Proposal for amendments regarding ECE/TRANS/WP.29/2022/59

Modifications to ECE/TRANS/WP.29/2022/59 are in **bold** for new or ~~strike through~~ for deleted characters.

Model A

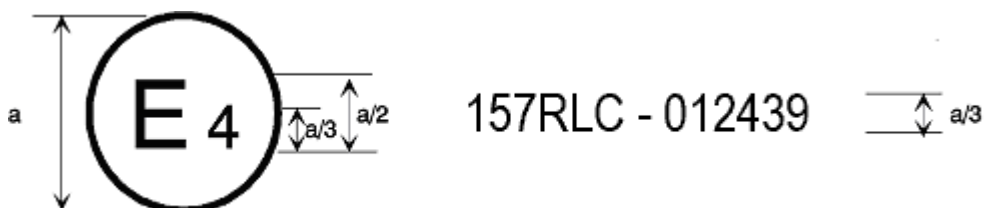
The above approval mark affixed to a vehicle shows that the vehicle type concerned has, with regard to ALKS, been approved in the Netherlands (E 4) pursuant to UN Regulation No. 157 under approval No. ~~002439~~ **012439** and is capable of a lane change procedure. The approval number indicates that the approval was granted in accordance with the requirements of UN Regulation No. 157 ~~in its original version~~ **with the 01 series of amendments incorporated.**

Model B

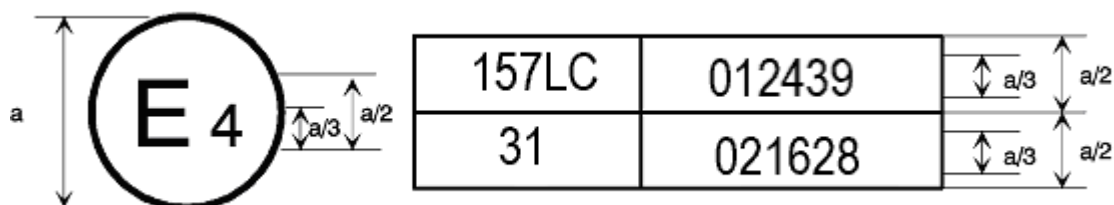
The above approval mark affixed to a vehicle shows that the vehicle type concerned has been approved in the Netherlands (E 4) pursuant to Regulations Nos. 157 (**capable of a lane change procedure**) and 31.¹ The approval numbers indicate that, at the dates when the respective approvals were given, UN Regulation No. 157 ~~was in its original version~~ **included the 01 series of amendments** and UN Regulation No. 31 included the 02 series of amendments.
